**Thursday, August 13, 2026
Monroe Planning Board Workshop Meeting**

TOWN OF MONROE
PLANNING BOARD
TECHNICAL REVIEW COMMENTS

PROJECT NAME: FBG HARRIMAN UPPER RETAIL LLC
PROJECT LOCATION: HARRIMAN COMMONS 2-1-34.2
PROJECT NUMBER: 10-11; 19-181
DATE: 11 AUGUST 2026
CONSULTANT: LANGAN
PLAN DATE: 23 DECEMBER 2019
DESCRIPTION: THE PROJECT IS PROPOSING THE CONVERSION OF RETAIL SPACE TO RESTAURANT SPACE WITH OUTDOOR DINING.

WARNING:
IT IS A VIOLATION OF THE NYS EDUCATION LAW
ARTICLE 146 FOR ANY PERSON UNLESS HE IS ACTING
UNDER THE DIRECTION OF A LICENSED
PROFESSIONAL ENGINEER, TO ALTER THIS ITEM IN
ANY WAY.

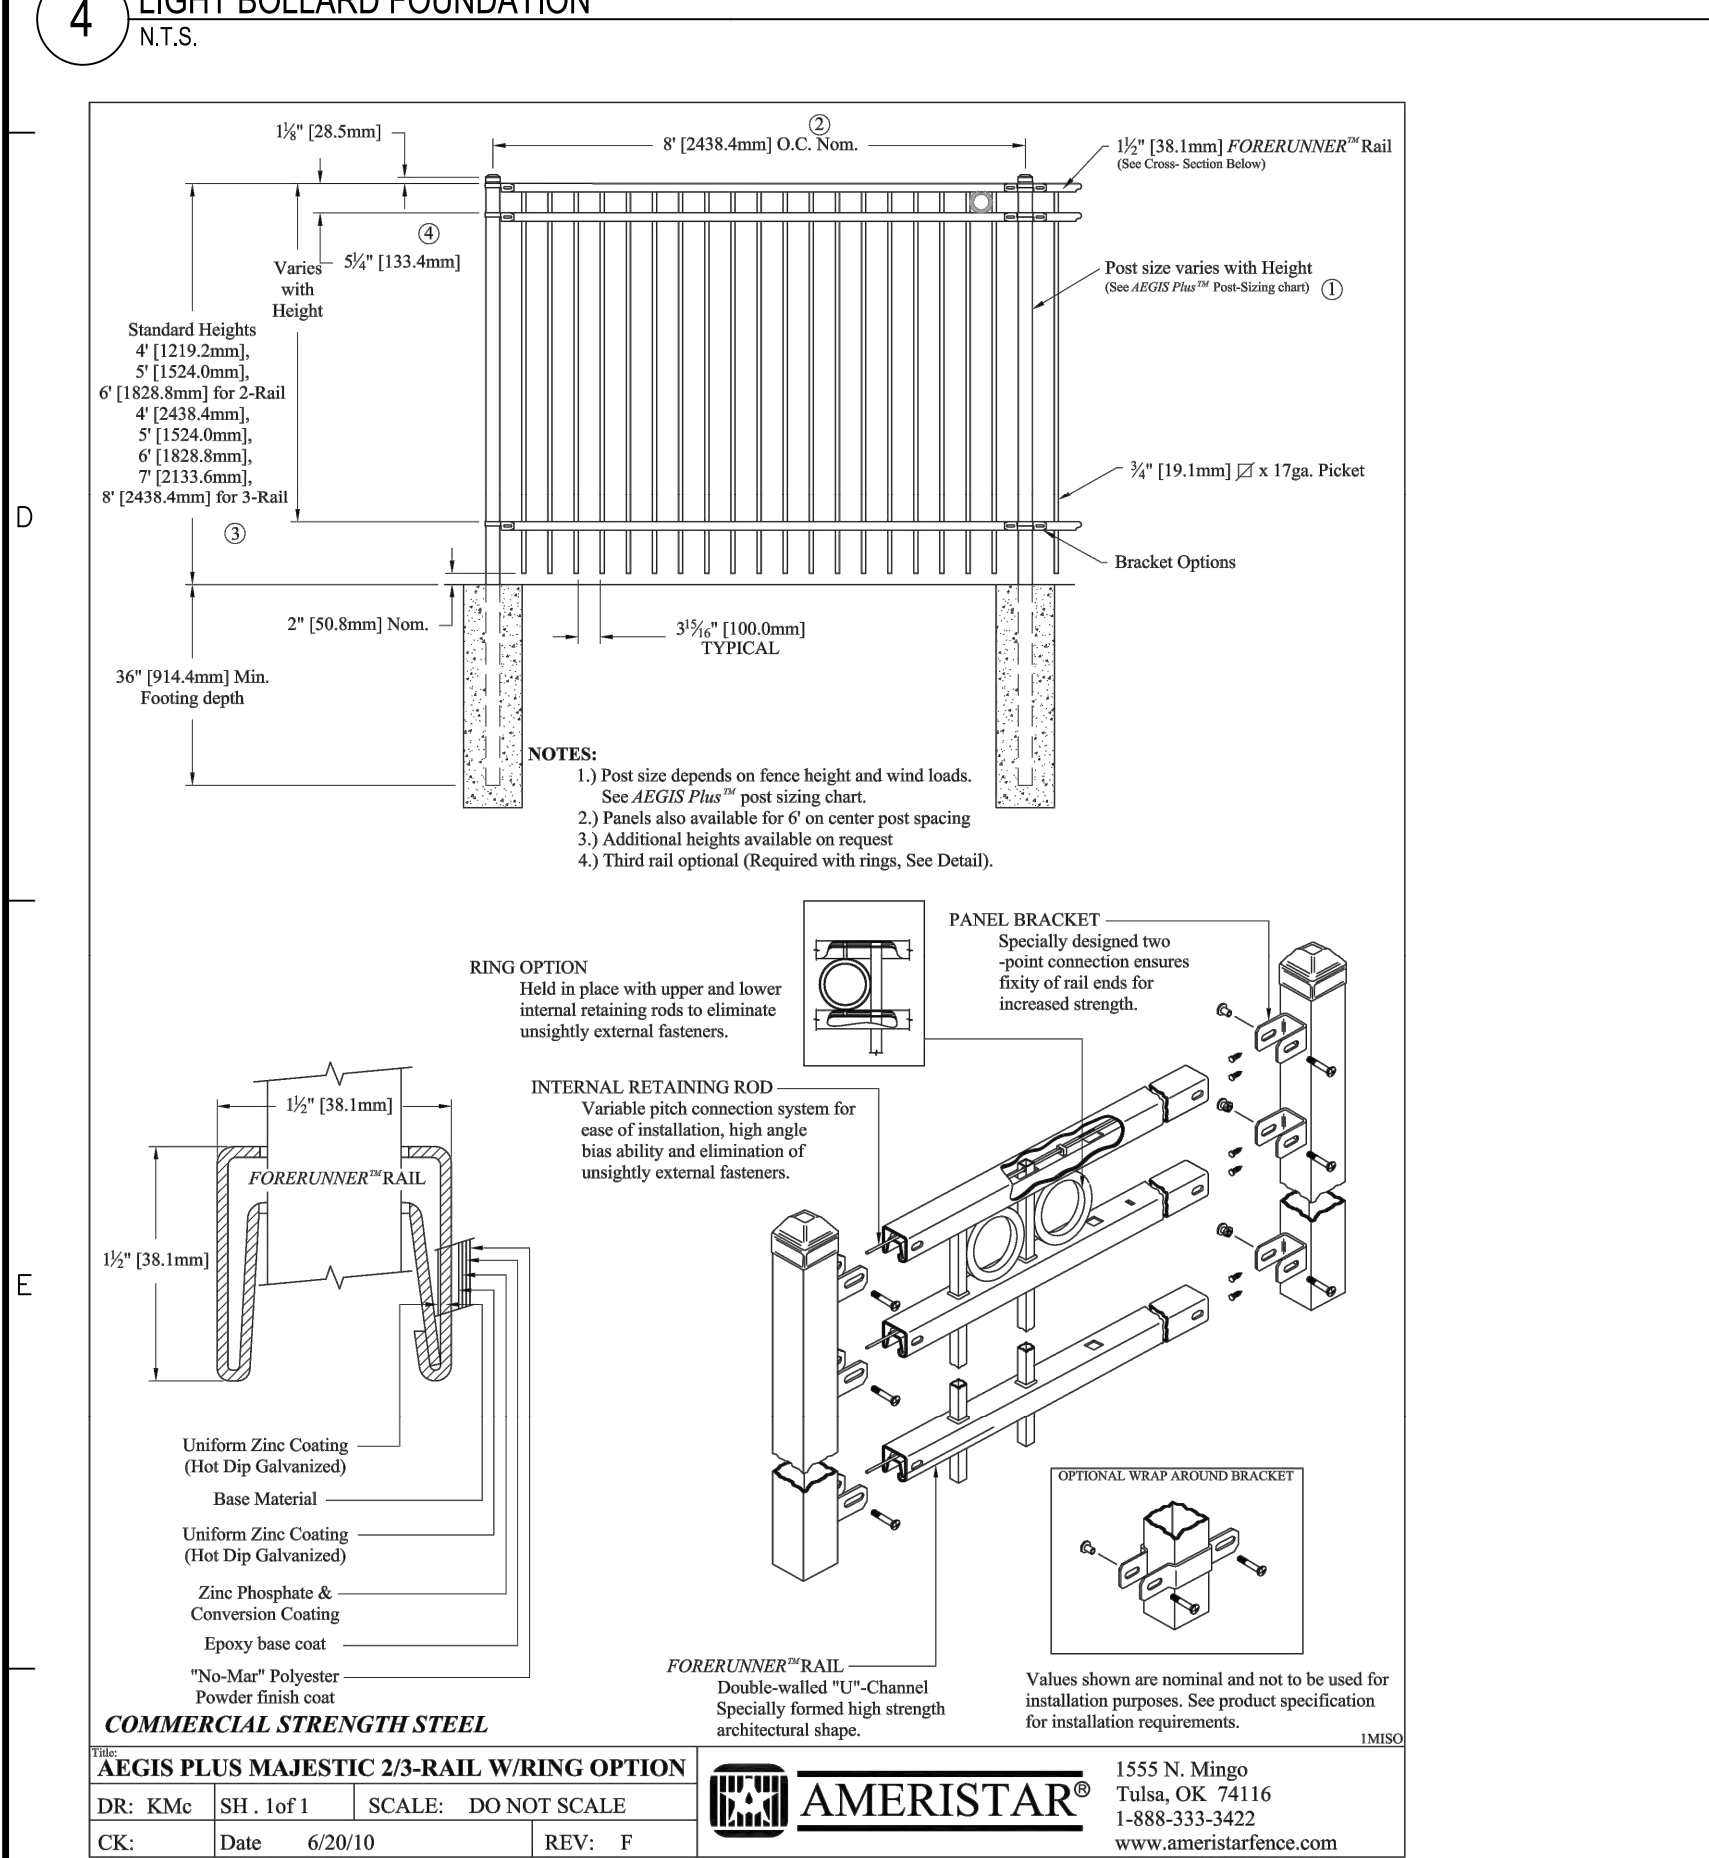
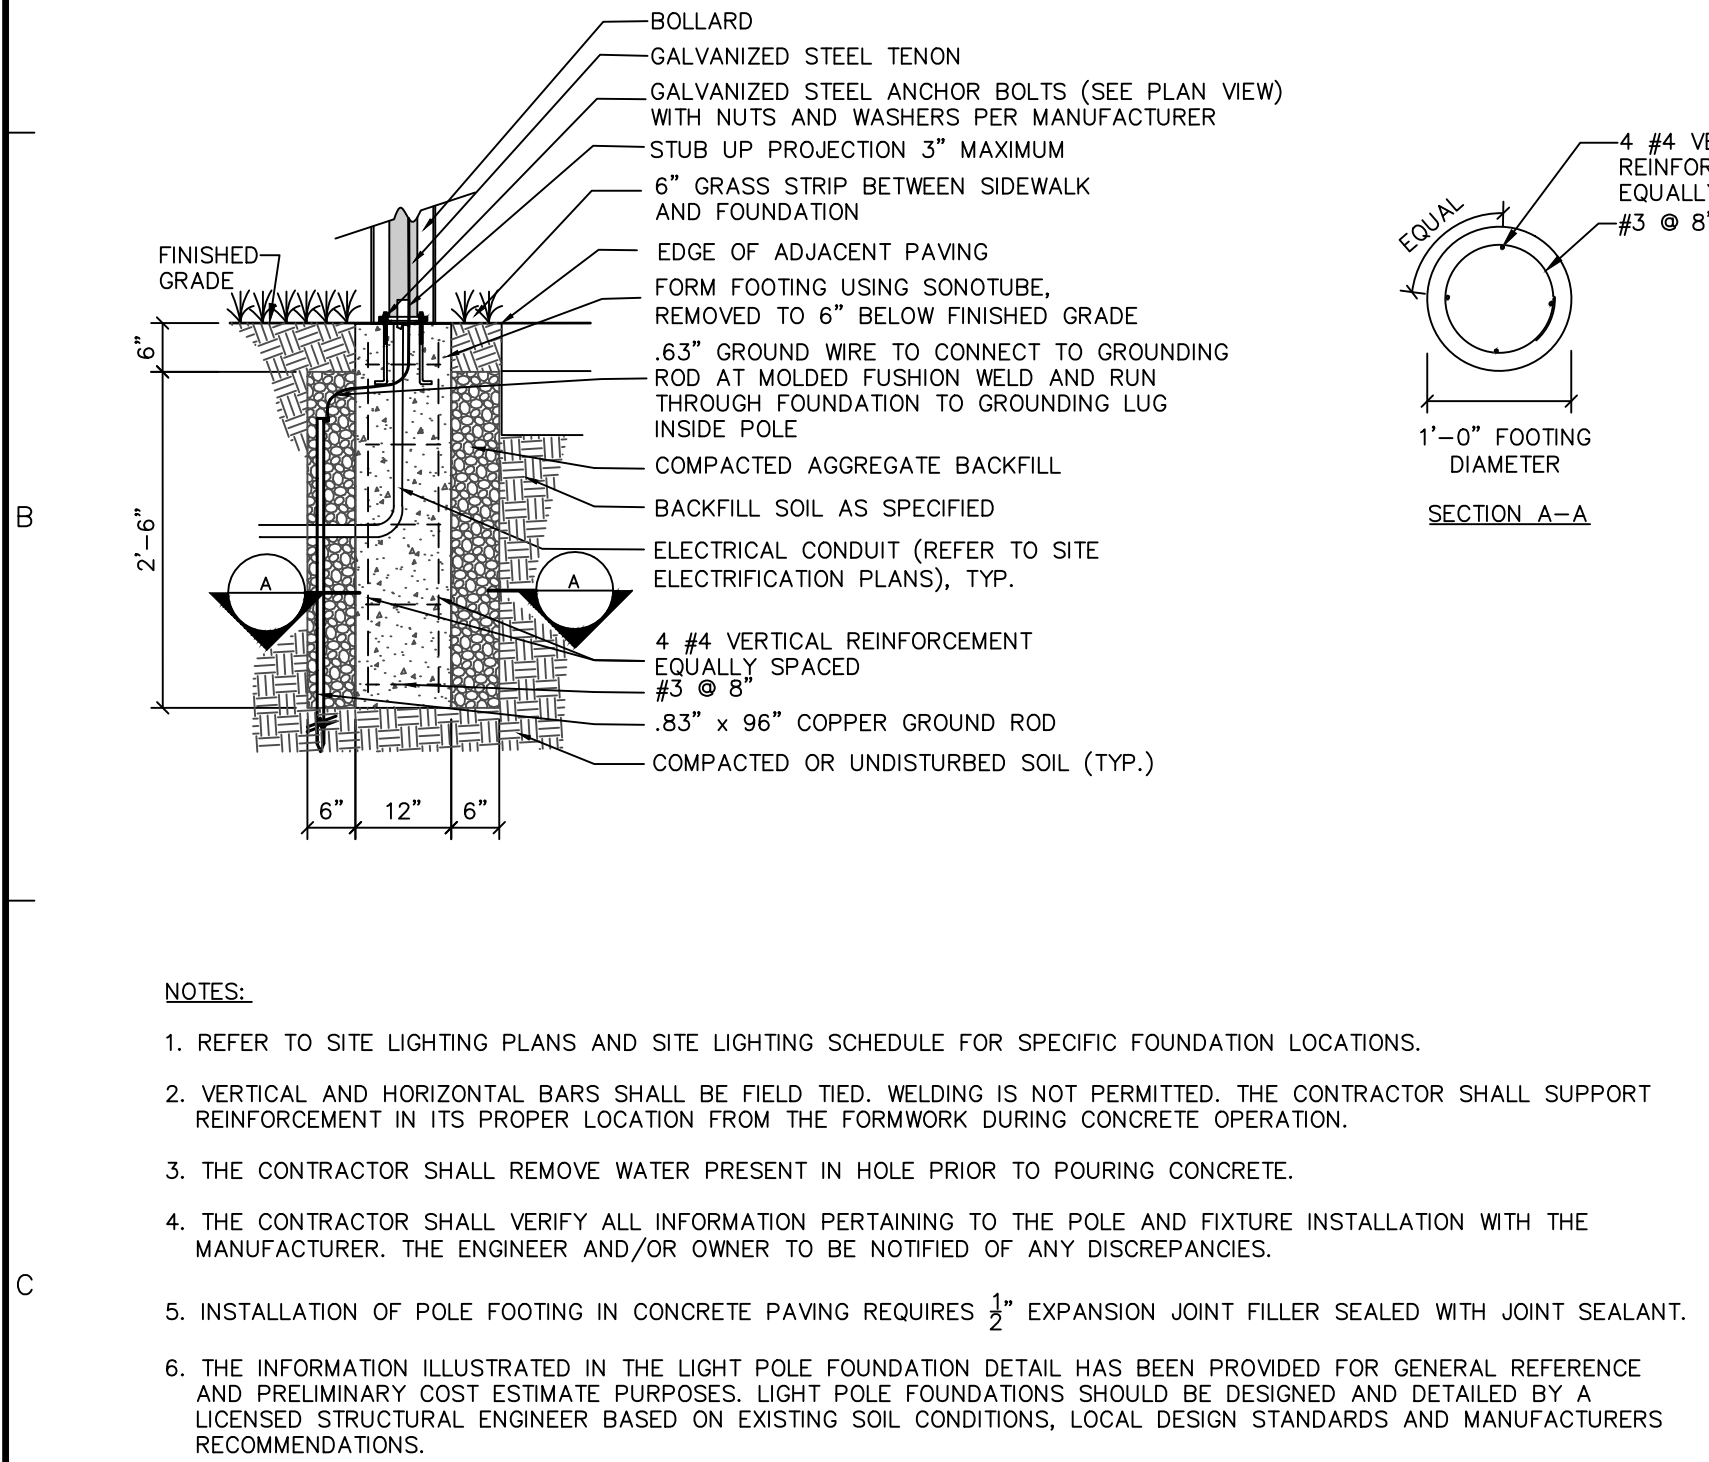
1. The site plan set submitted is from prior applications in 2019. The Design Professional should confirm that the plans accurately reflect the current site conditions.
2. The plans should clarify the location of the property boundary.
3. The Planning Board approval block should be updated to the latest version and placed in the lower right-hand corner of each plan sheet.
4. Verify that the proposed improvements do not impact the existing utility rights-of-way.
